CONVAIR

COMMERCIAL CHANGE PROPOSAL

CUSTOMER: Delta Air Lines Inc.

MODEL: 22-2 (Convair "880")

FIGURE 3.12-1

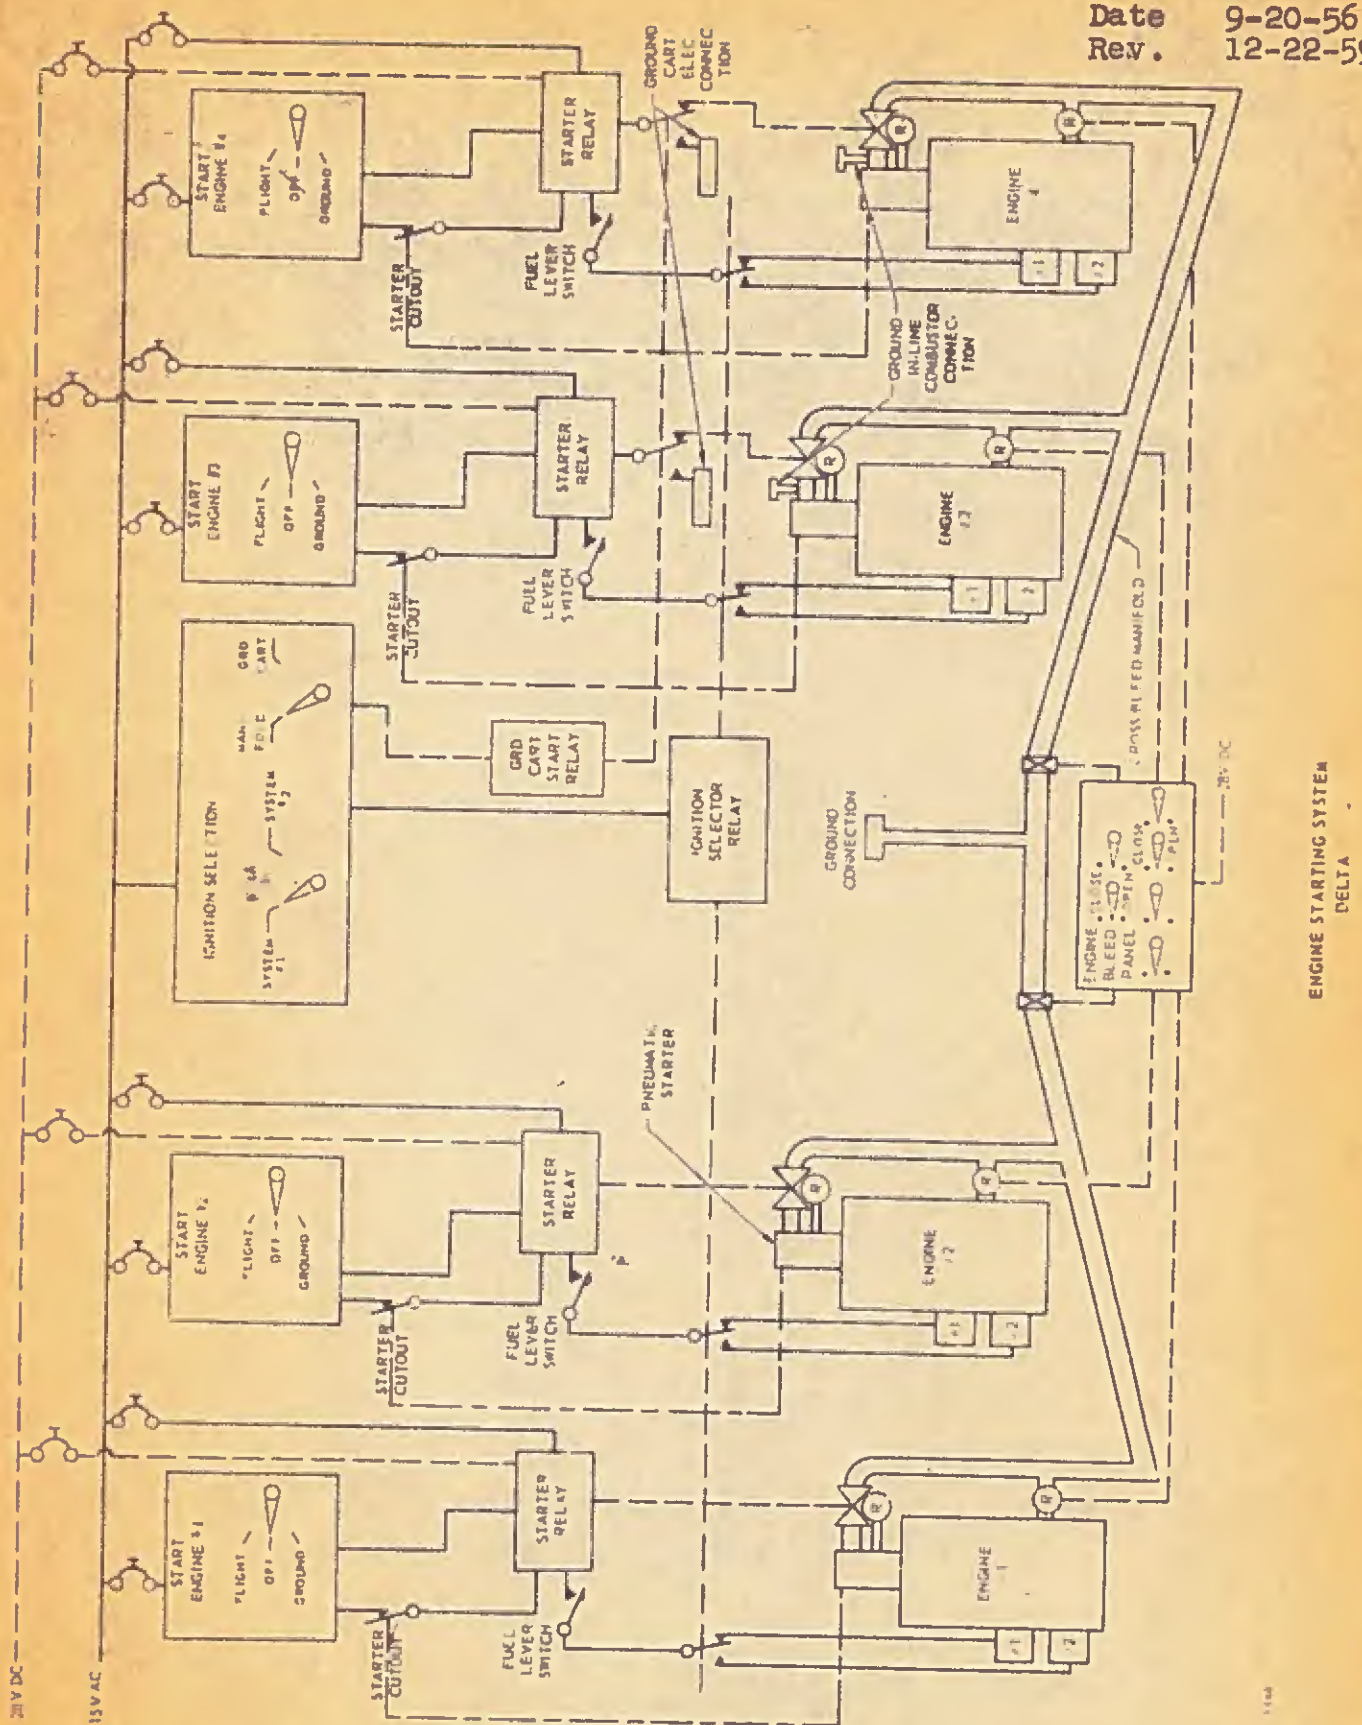
Page 12C, FIGURE 3.1-3 - MAXIMUM LEVEL FLIGHT SPEEDS
Page 56A, FIGURE 3.12-1 - ENGINE STARTING SYSTEM
Page 62C, FIGURE 3.14-3 - FLIGHT ENGINEER'S PANEL
Page 62D, FIGURE 3.14-4 - PILOT'S & COPILOT'S OVERHEAD CONTROL PANEL
Page 89A, FIGURE 3.16-1 - A-C POWER SYSTEM
Page 89B, FIGURE 3.16-2 - D-C POWER SYSTEM
Page 102D, FIGURE 3.17-2 - PITOT STATIC SYSTEM
Page 115A, FIGURE 3.19-1 - TEMPERATURE MEASUREMENT PLANE
Page 122A, FIGURE 3.20-1 - AIR CONDITIONING PRESSURIZATION SYSTEM
Page 122B, FIGURE 3.20-2 - ESTIMATED CABIN PRESSURE SCHEDULE
Page 122C, FIGURE 3.20-3 - TEMPERATURE VS ALTITUDE
Page 122D, FIGURE 3.20-4 - CABIN AIR CONDITIONING SYSTEM PERFORMANCE

Page 122A, FIGURE 3.20-1 AIR CONDITIONING PRESSURIZATION SYSTEM: /

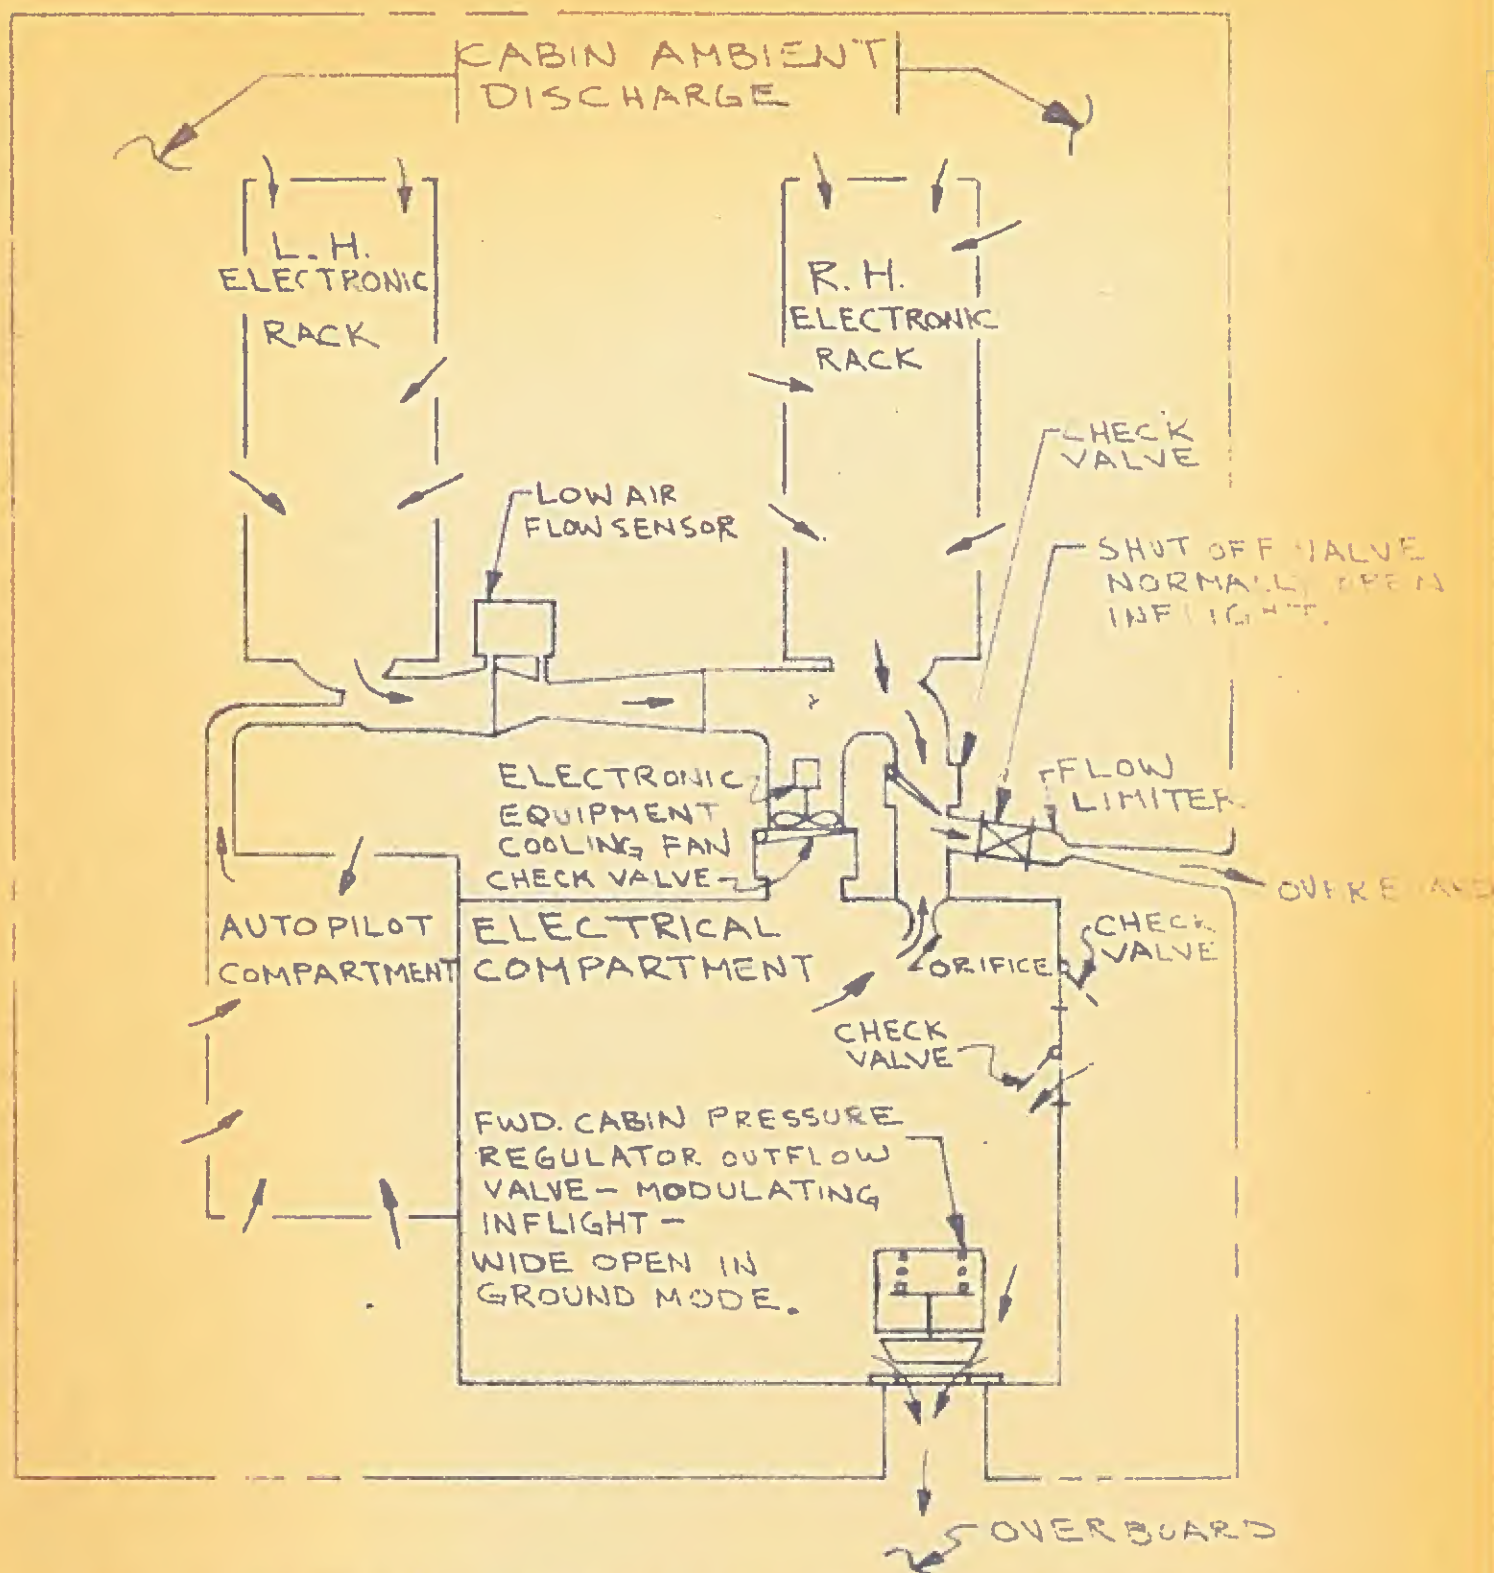
Above illustration to be revised to show the effects of this proposal.

Enclosure: (A) One copy of Convair Sketch - AIRFLOW PATTERN SHOWN FOR NORMAL INFLIGHT MODE (For information only)

Enclosure: (B) One copy of Convair Sketch - ELECTRICAL EQUIPT COOLING VALVE LOCATION (For information only)

Page 38a, FIGURE 3.8-1 MAIN LANDING GEAR SYSTEM:

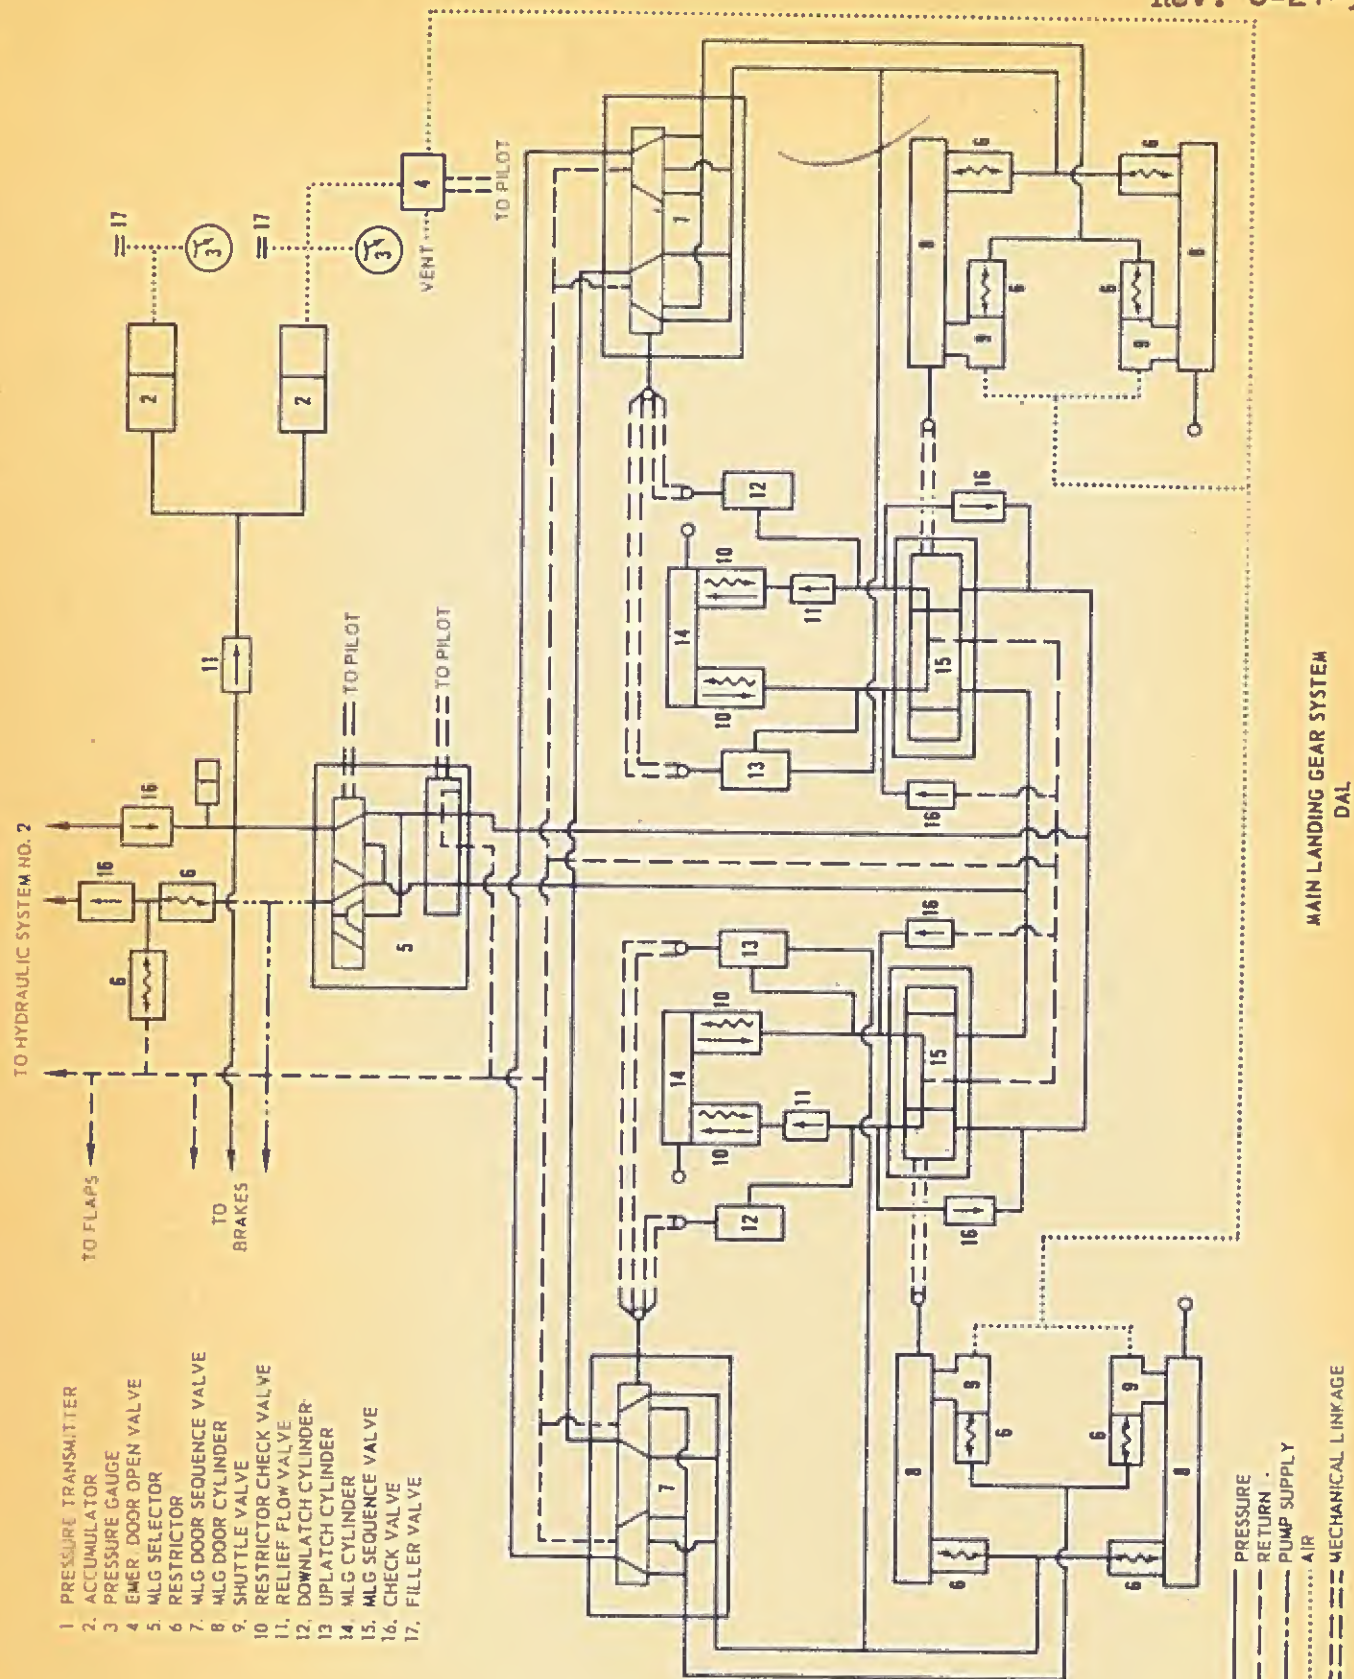
Reason for Change: To incorporate an up to date Main Landing Gear System schematic.

ENCLOSURE: (A) One copy FIGURE 3.8-1 MAIN LANDING GEAR SYSTEM
(Revised)

Figure 3.14-6

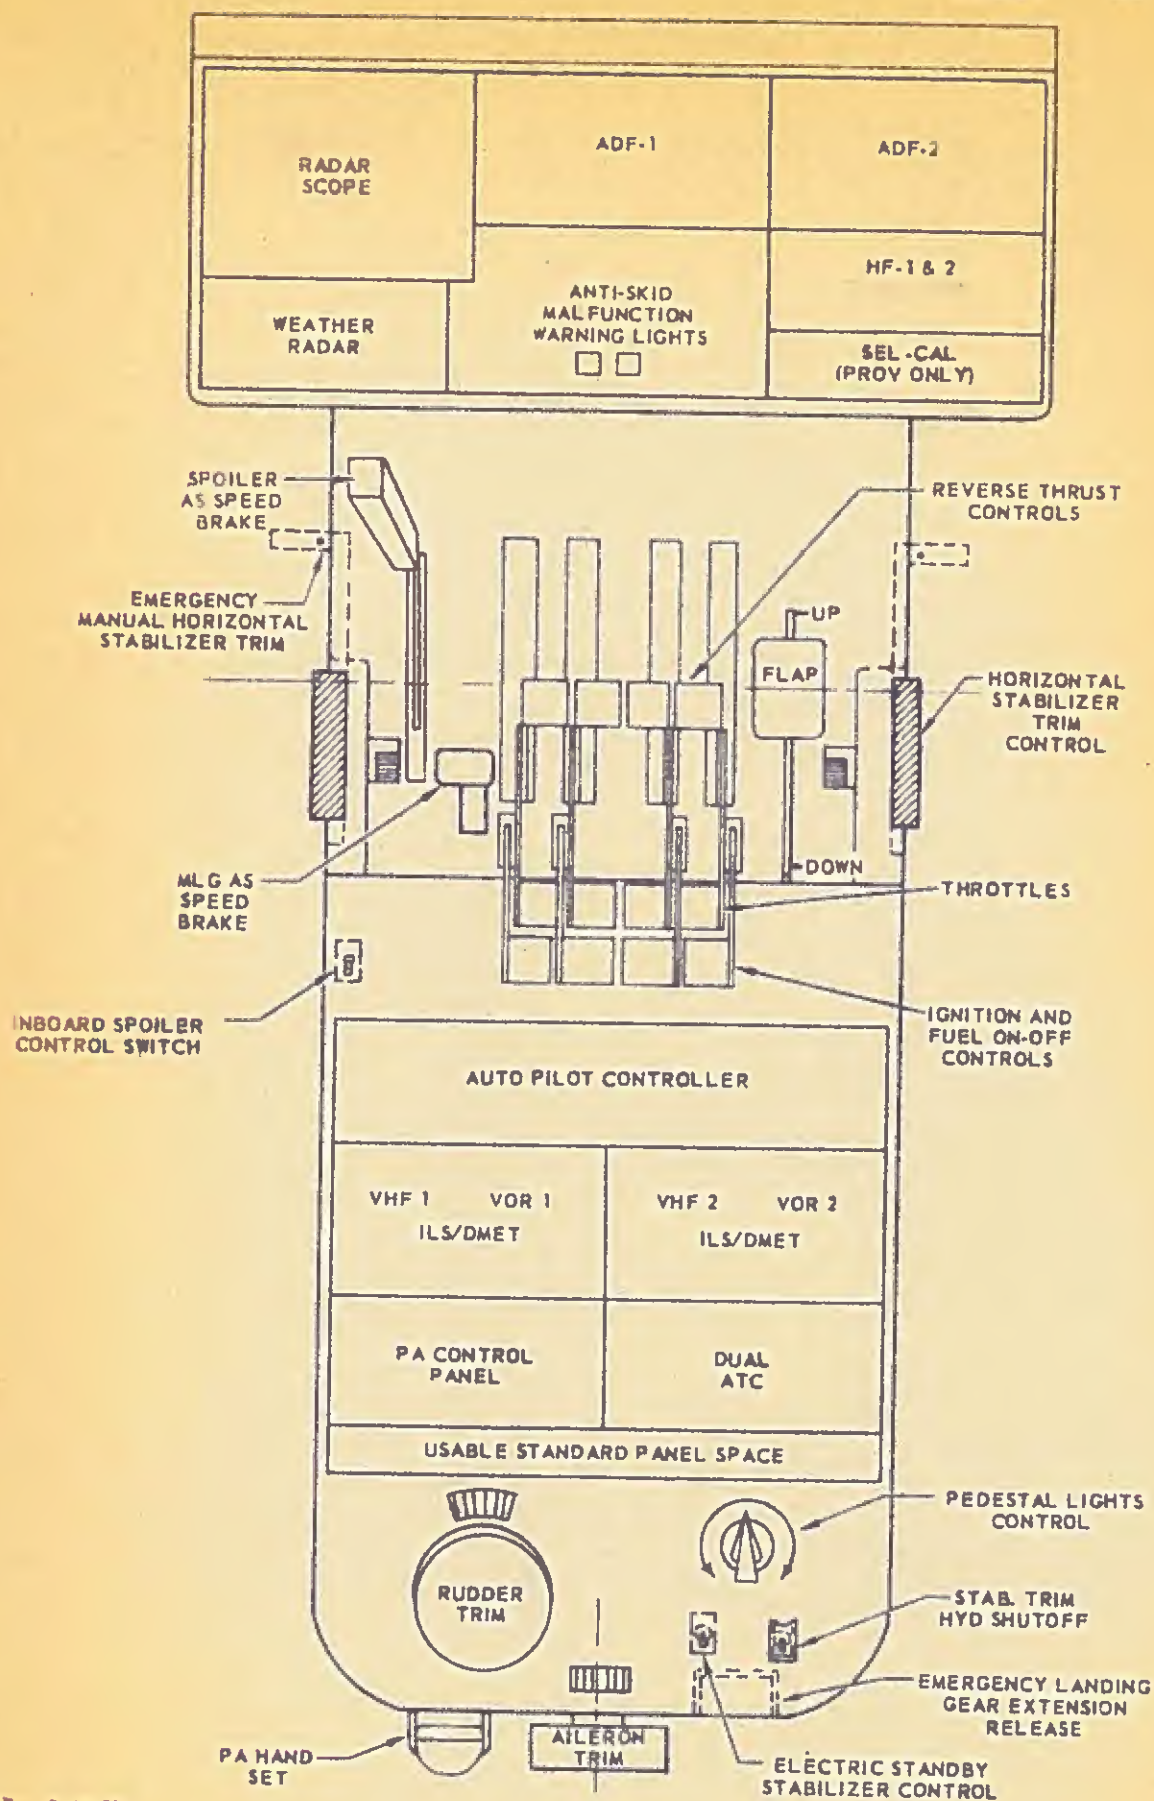
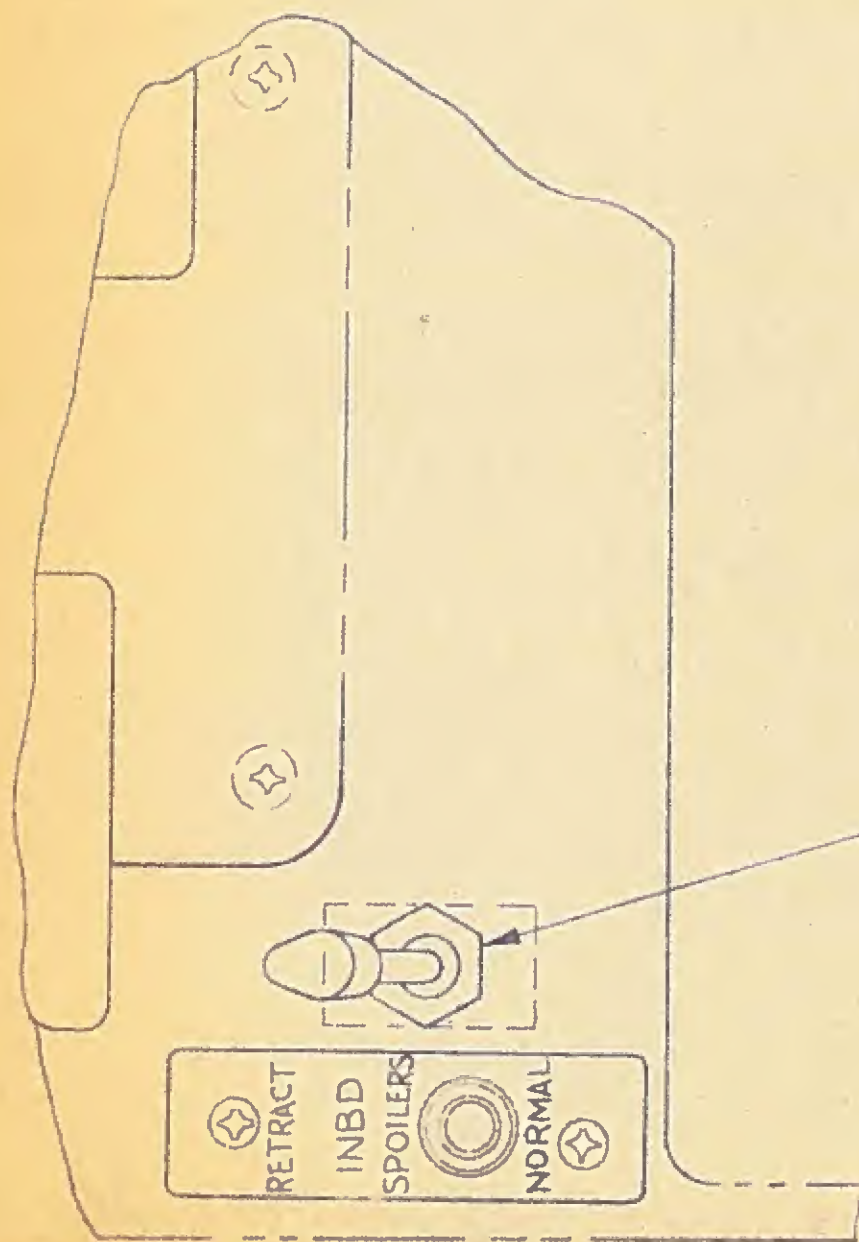
- Enclosures: (A) One copy of Figure 3.14-6, PILOT'S AND COPILOT'S
PEDESTAL (Revised)
- (B) One copy of Convair Sketch showing labeling of Inboard
Spoiler Switch (For information only.)
